AMENDMENT - INVITATION TO TENDER

Title-Sujet: Construction – Wabasca-Desmarais Detachment	
Solicitation No. - No. de l'invitation 201804138	Date 1 février, 2018
Client Reference No. - No. De Référence du Client 201804138	Amend No.- No. du modif. 007
GETS Reference No. - No. de Référence de SEAG 201804138	
Solicitation Closes –L'invitation prend fin at - à 16 :00 ET on - le Feb. 6th, 2018	
F.O.B. - F.A.B. Destination	
Address Enquiries to: - Adresser toutes questions à: jordan.mckenna@rcmp-grc.gc.ca	
Telephone No. - No de telephone 613.843.5518	Fax No. - N° de FAX:
Destination of Goods, Services, and Construction: Destinations des biens, services et construction:	
Delivery Required - Livraison exigée:	Delivery Offered - Livraison proposée
Name and title of person authorized to sign on behalf of Vendor/Firm Nom et titre de la personne autorisée à signer au nom du fournisseur/de l'entrepreneur

ADDENDUM No. 05

**GOVERNMENT OF CANADA
WABASCA-DESMARAIS GOVERNMENT BUILDING**

.3 Refer to DOMESTIC WATER HEATER SCHEDULE

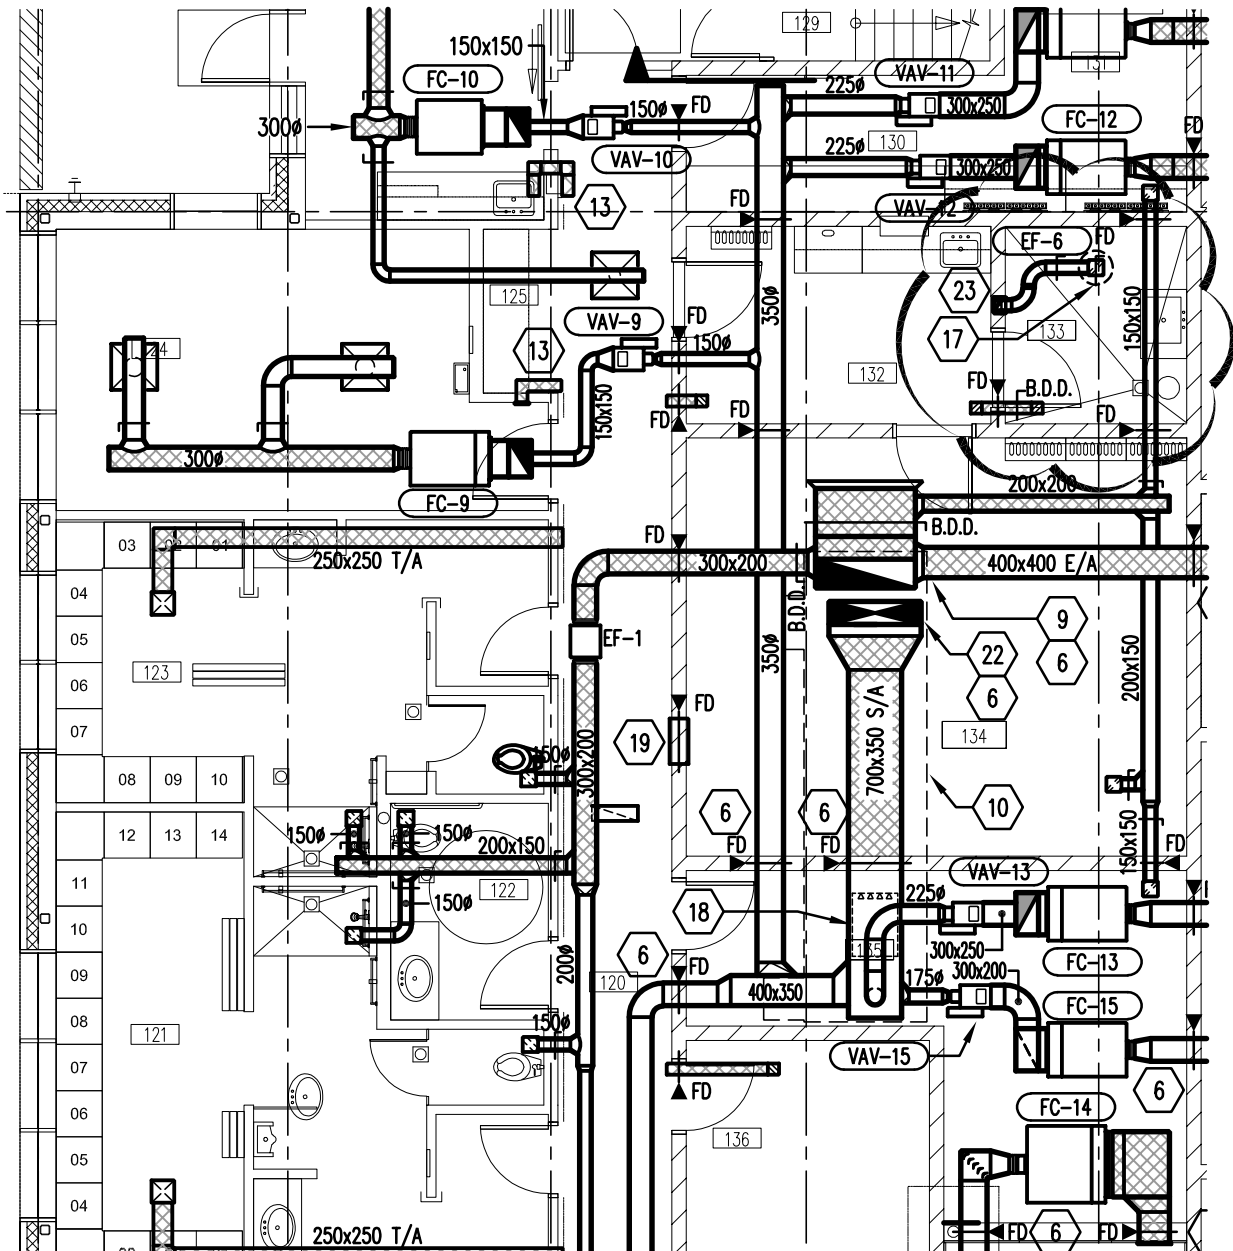
ADD: Add note to provide condensate neutralization kit for DWH-1 and DWH-2.

M4.0-MSK-01

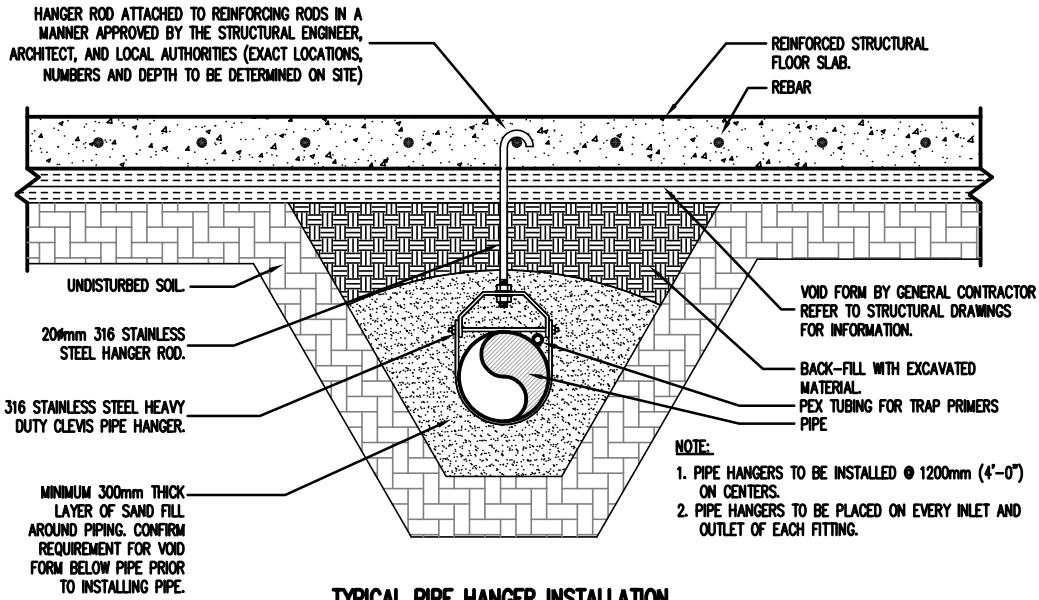
REVISE: Revise Room 13 exhaust layout and Keynotes 17 and 23 as per attached sketch M4.0-MSK-01.

17 PROVIDE 200x200 INSULATED DUCT FROM CEILING GRILLE UP TO EXHAUST FAN EF-6 ON ROOF. PROVIDE FIRE DAMPER AT CEILING EXIT, SECURITY BARS AND INSULATED MOTORIZED DAMPER AT ROOF EXIT.

**STRUCTURAL SLAB UNDERGROUND
PIPE SUPPORT DETAIL
(ADDENDUM M2)**

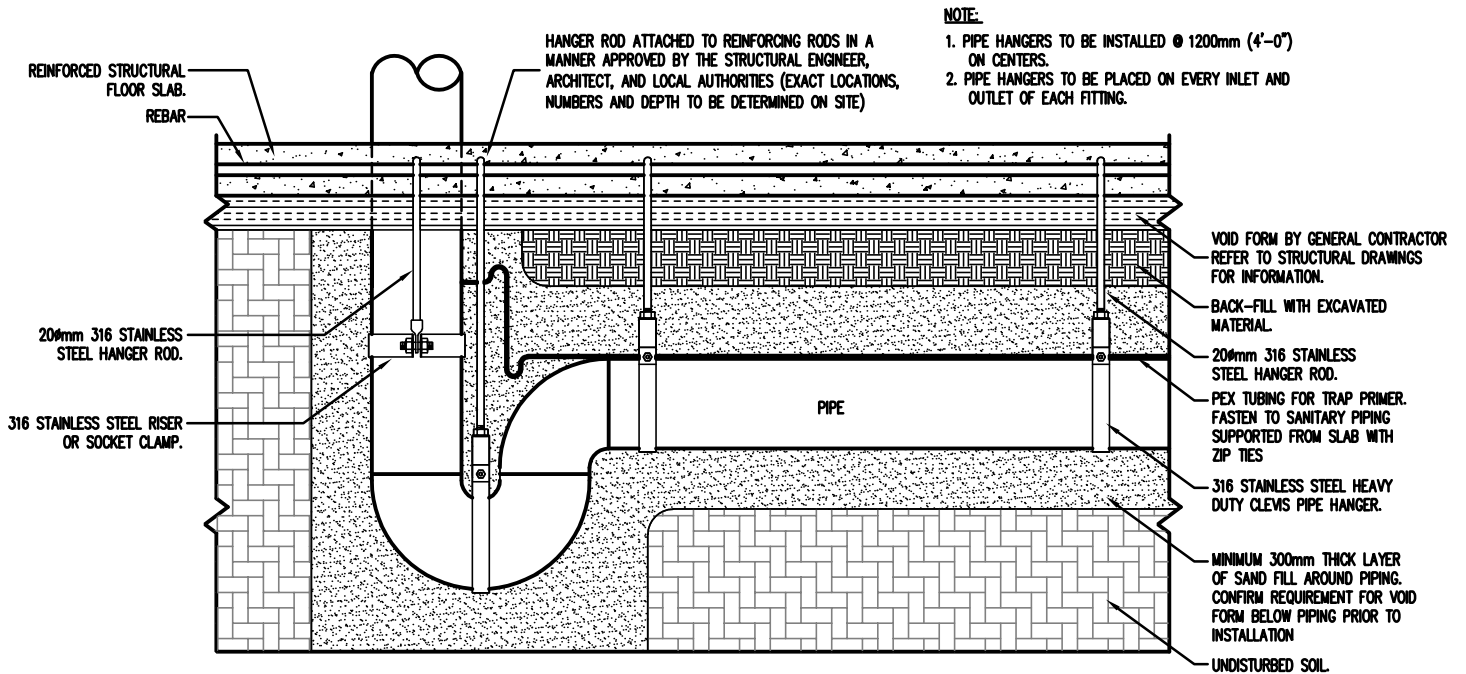
ADD: Add below slab pipe support detail as per attached.

2 CAR PEDESTAL RECEPTACLE DETAIL
SCALE: NTS

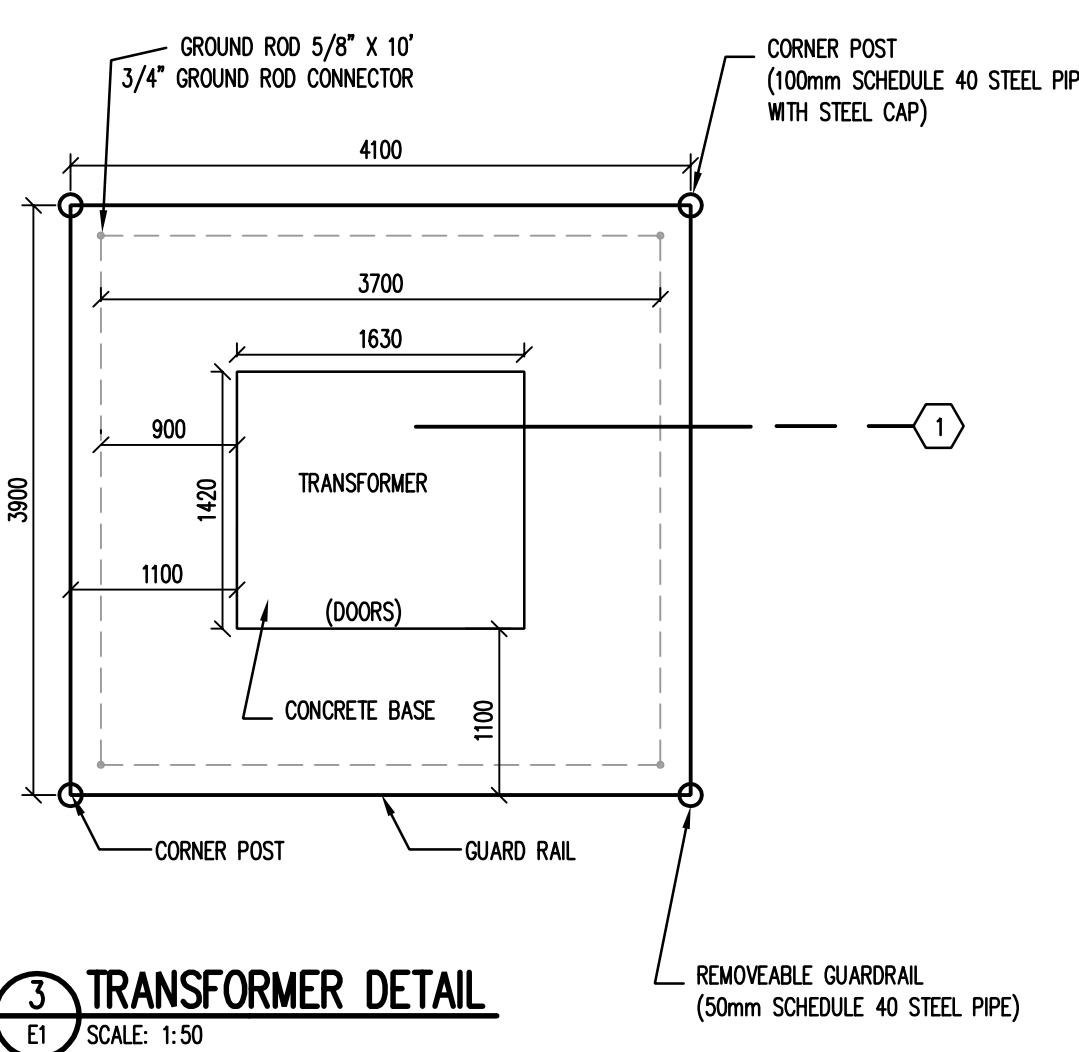
REVISE: Detail 2: Revise the note. The duplex receptacle is only on a single side as per the site plan layout. Remove the (ON EACH SIDE, FRONT & BACK).

POWER/DATA PLAN
E2.0 SCALE: 1:100

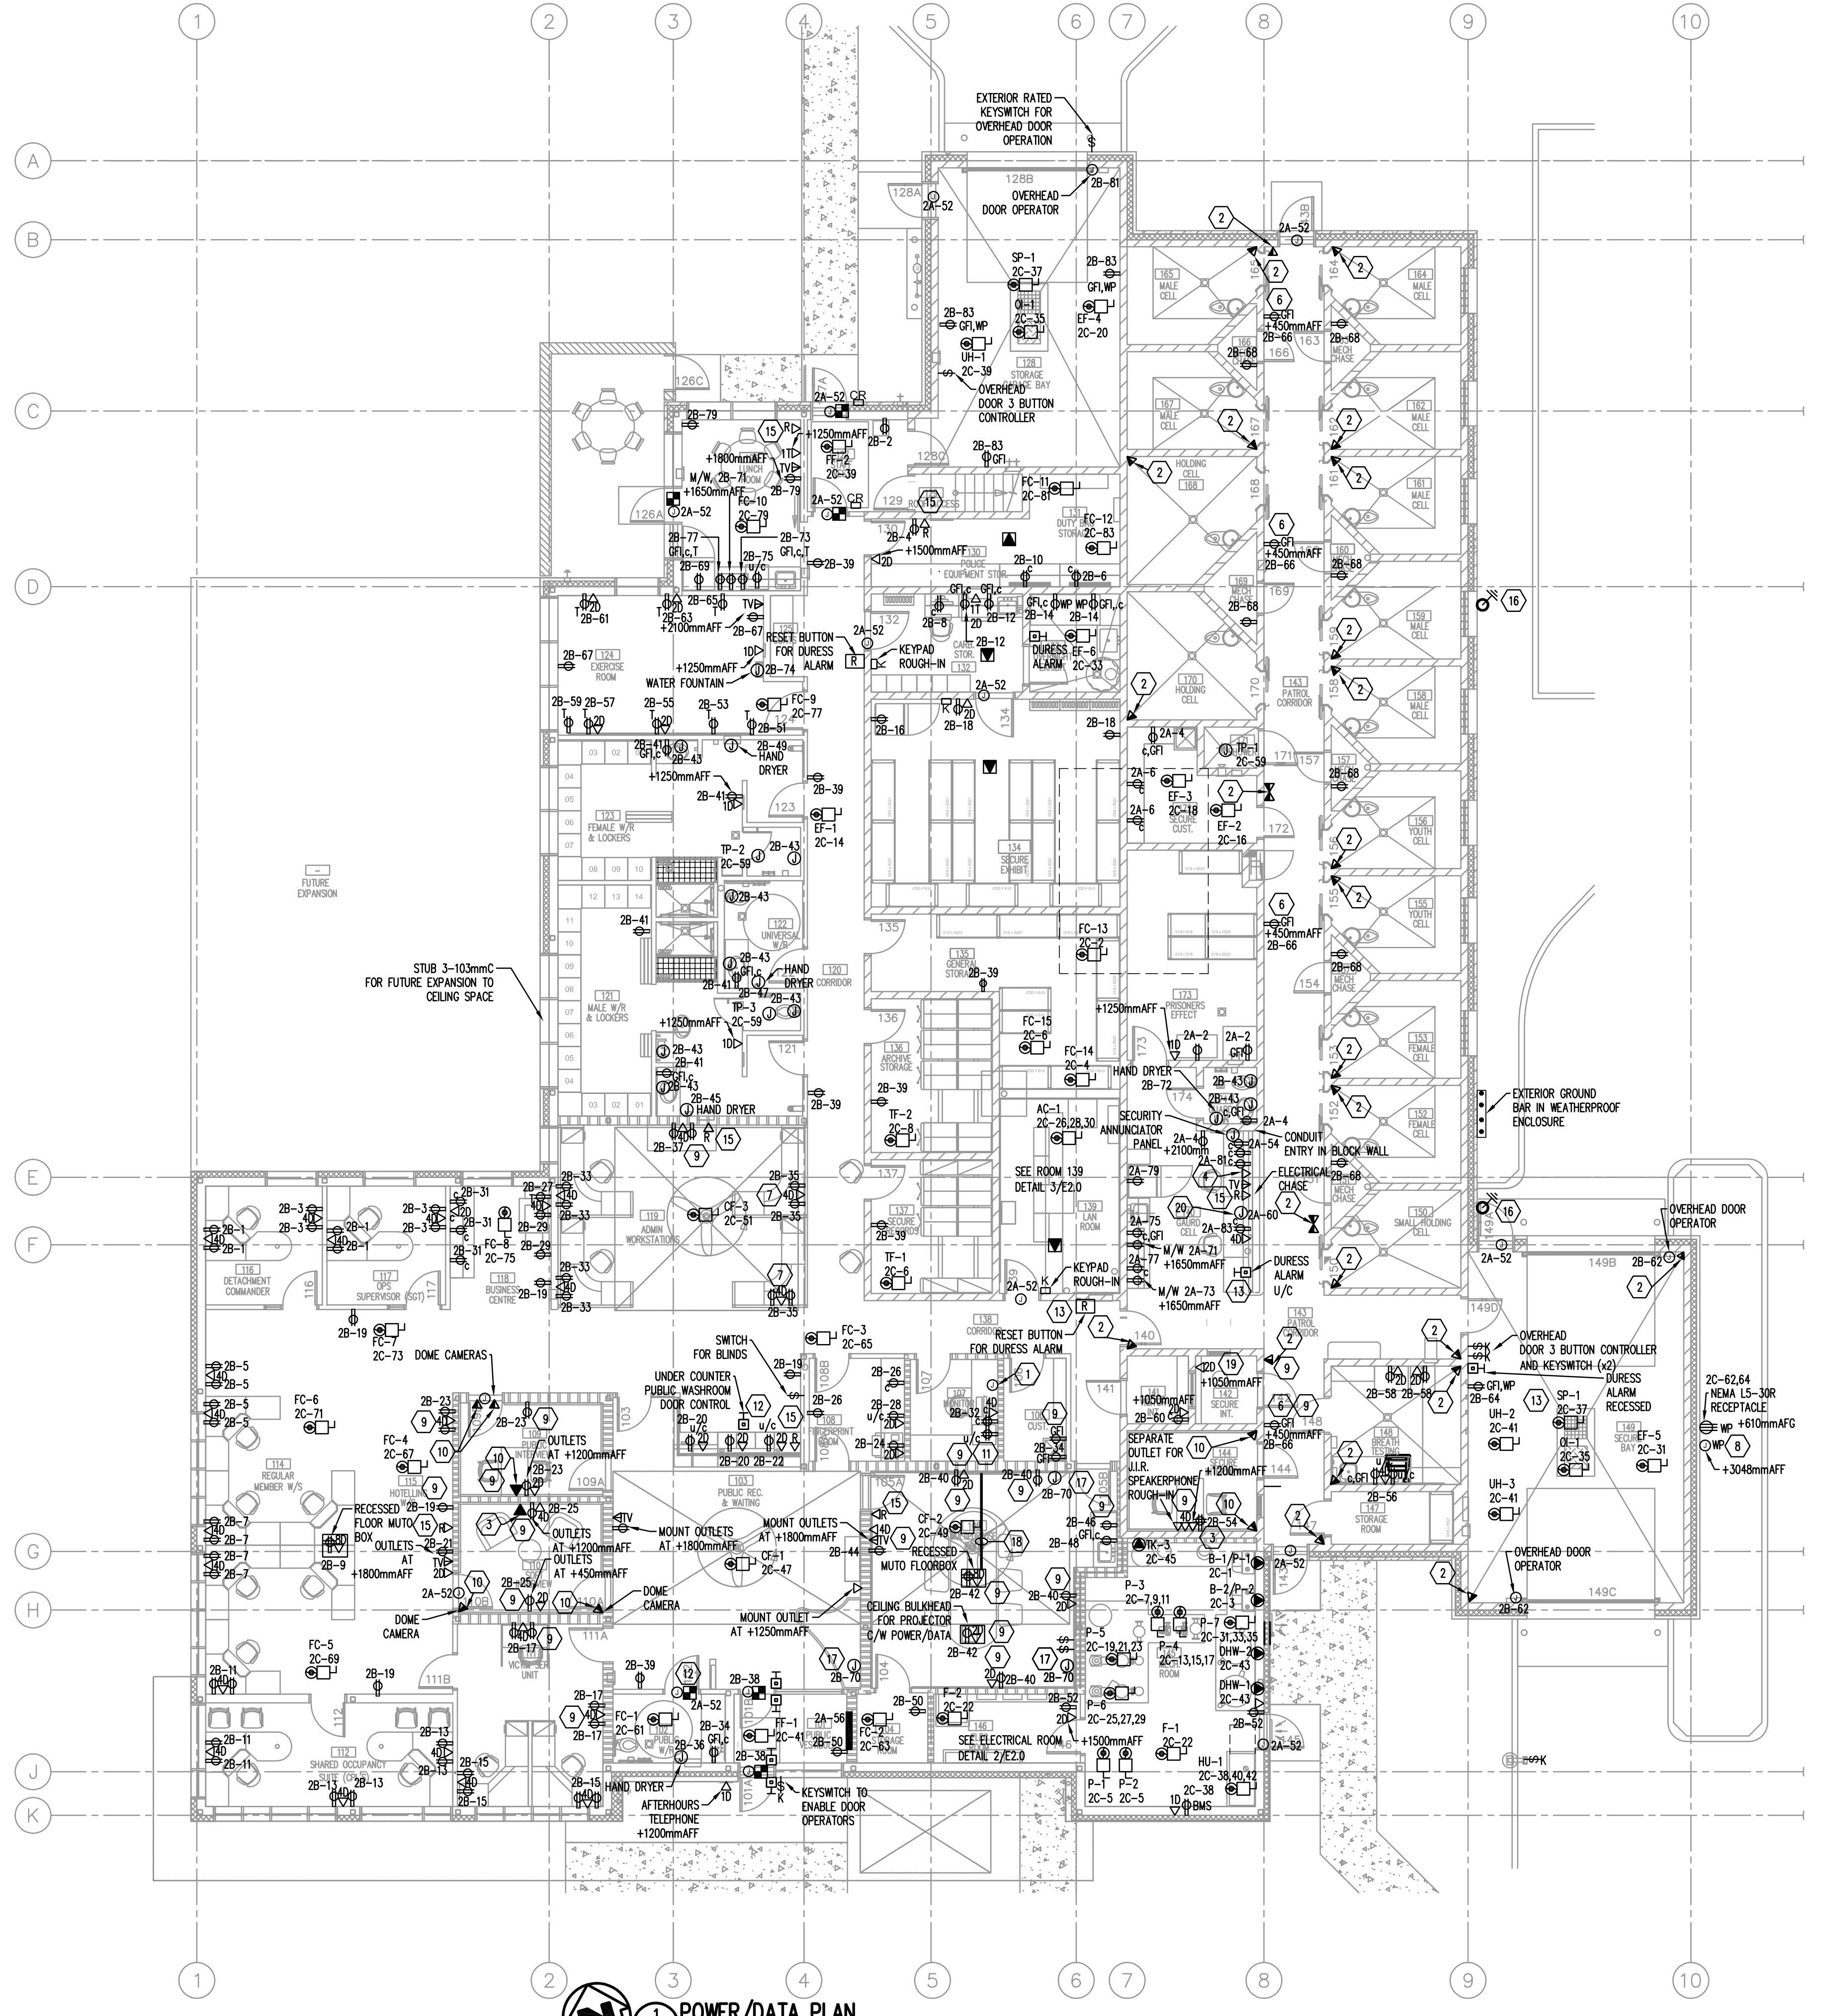
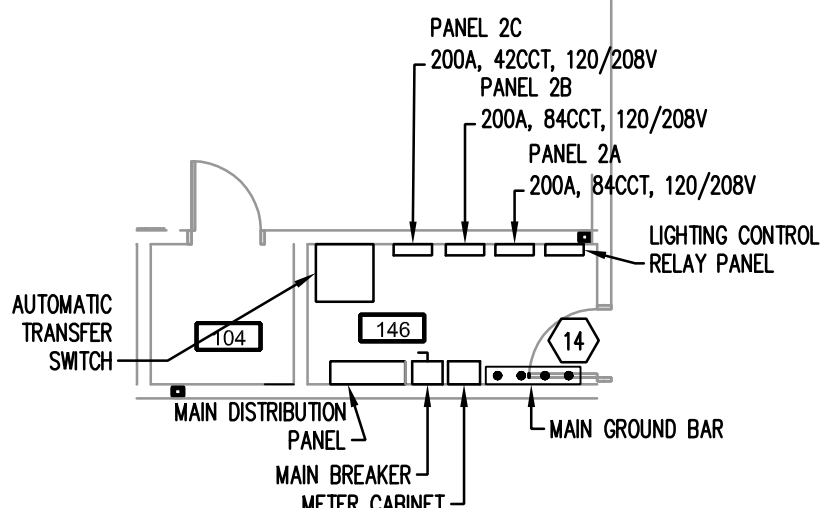
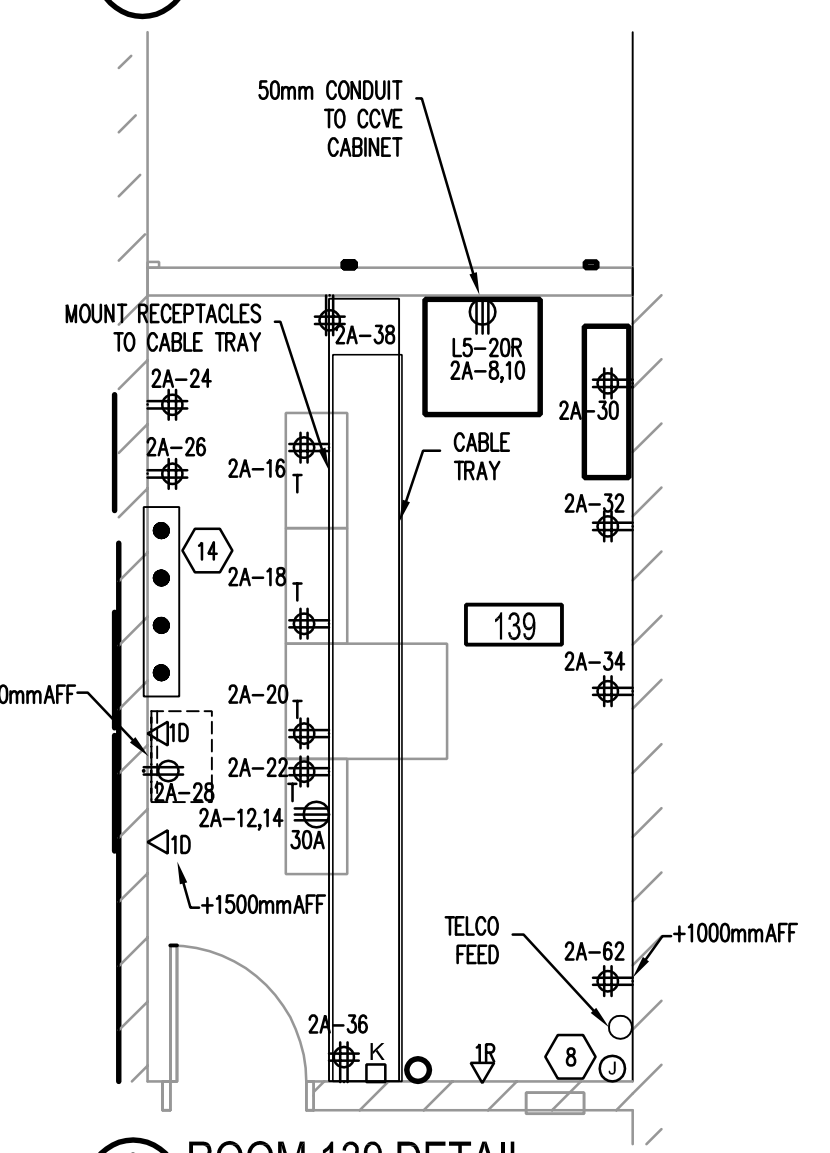
REVISE: Drawing has been re-issued with this addendum to address coordination with the architectural base plans and to reflect some minor additions. Changes include the addition of overhead door operator & switch outside 128; changes to room 133; added dome cameras to room 111 & 112; and selected minor power & data additions.
